Central Healdsburg Avenue Plan Final EIR

State Clearinghouse #2012112011

November 26, 2013

2. COMMENT LETTERS AND RESPONSE TO COMMENTS

Figure 3.12-1

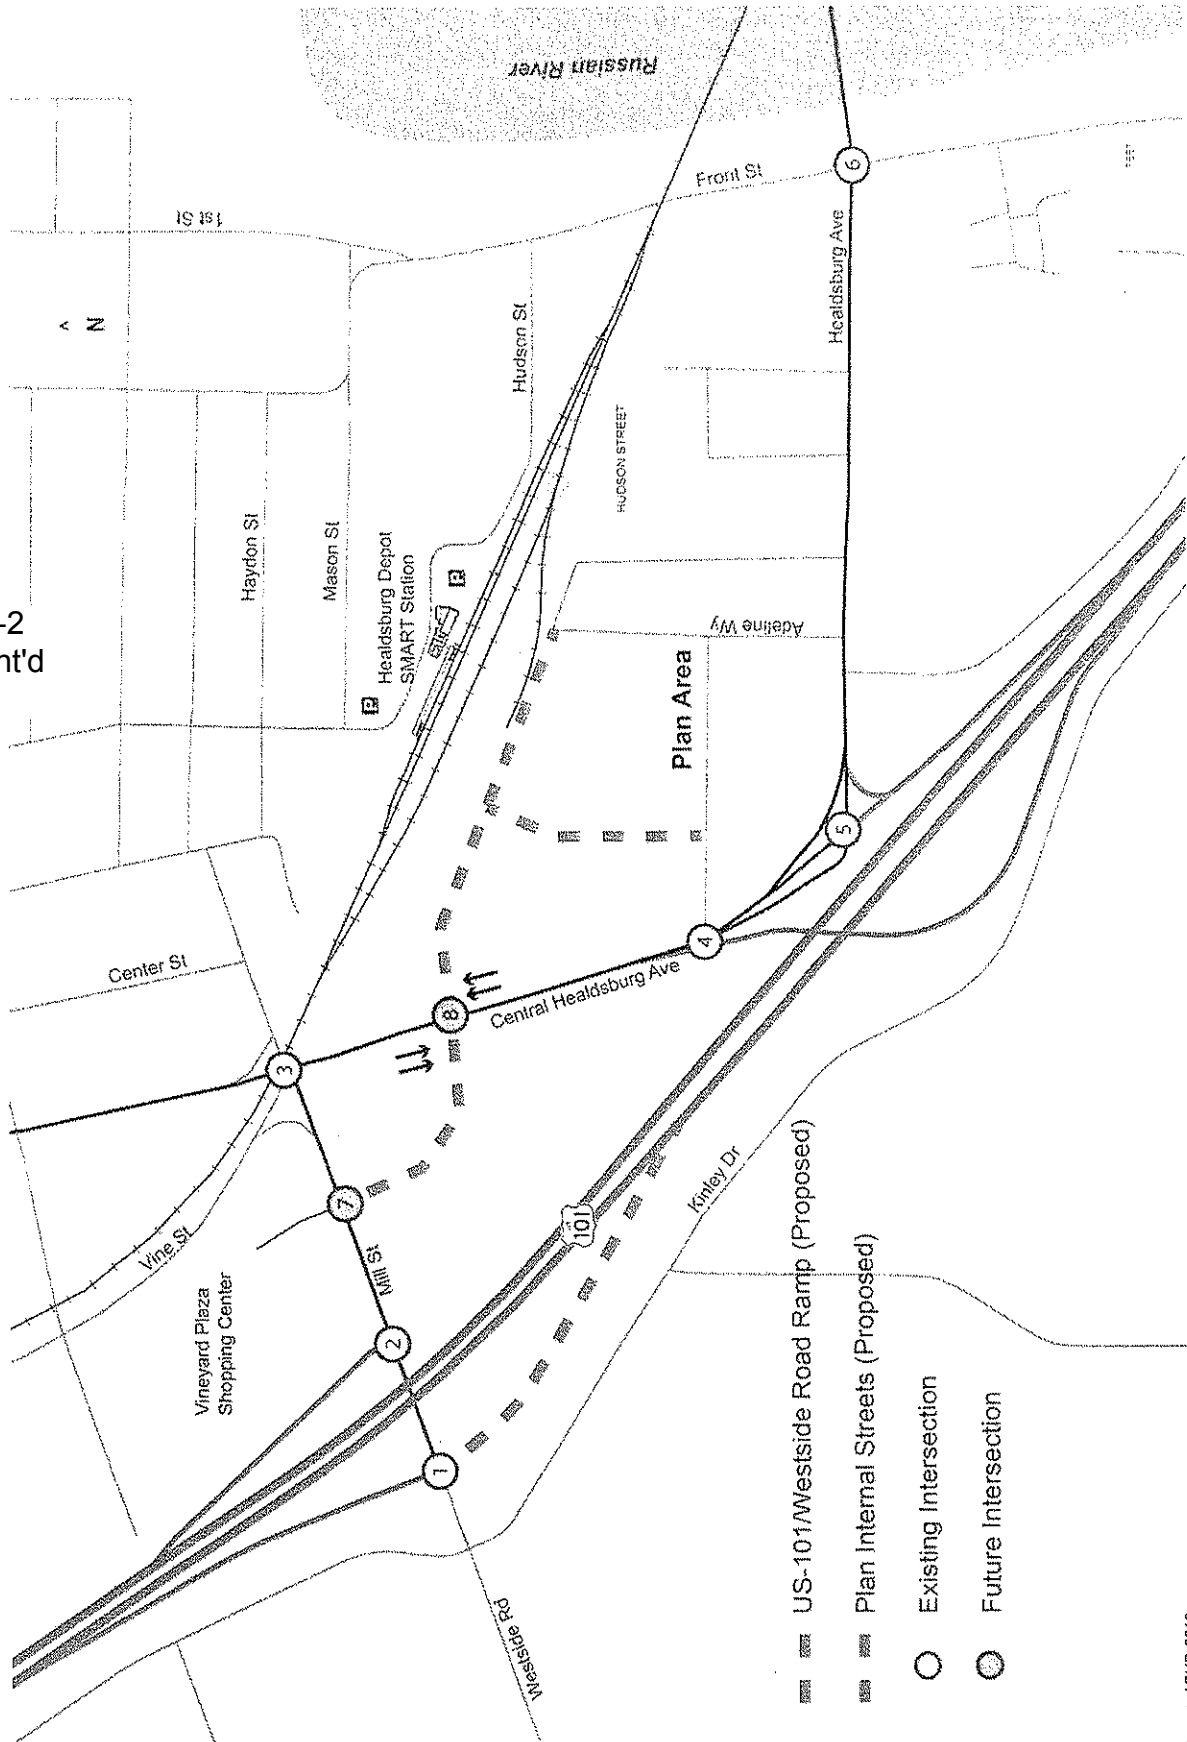
The CHAP Transportation Report shows a diagram of 'New Connector Streets' in Figure V-2 on page 4 that differs from that shown as new 'Local/Collector Streets' on Figure 3 on page 7 and on Figures 8-11 on pages 26-29 [as Intersection 8].

Figure 2 (which also has a label of V-2) on page 4 of the Transportation Report, included as Appendix E in the Draft EIR, shows the future illustrative street network that is envisioned by the Plan, while Figure 3 on page 7 focuses on the intersections that were studied. The impact to the proposed "Intersection 8" was analyzed on pages 3.12-12 and 3.12-13 of the Transportation Section of the Draft EIR. The Cumulative impact to the proposed "Intersection 8" was analyzed on page 3.12-19 of the Transportation Section of the Draft EIR.

The approximate location for the proposed "Intersection 8" is shown on Figure 3.12-1 of the Draft EIR. The "New Connector Streets" described on page 5 of the Transportation Report is a general description of the illustrative street network that is proposed in the Plan. The item identified as "Healdsburg Avenue to one of the new streets extending north of Exchange Avenue" is illustrated on Figure 2 on Page 4 of the Transportation Report, as well as Figure 2-5 of the Draft EIR. It is the first "Potential Street Alignments" shown parallel with, and to the north of, Exchange Avenue. The location of "Intersection 8" is further north.
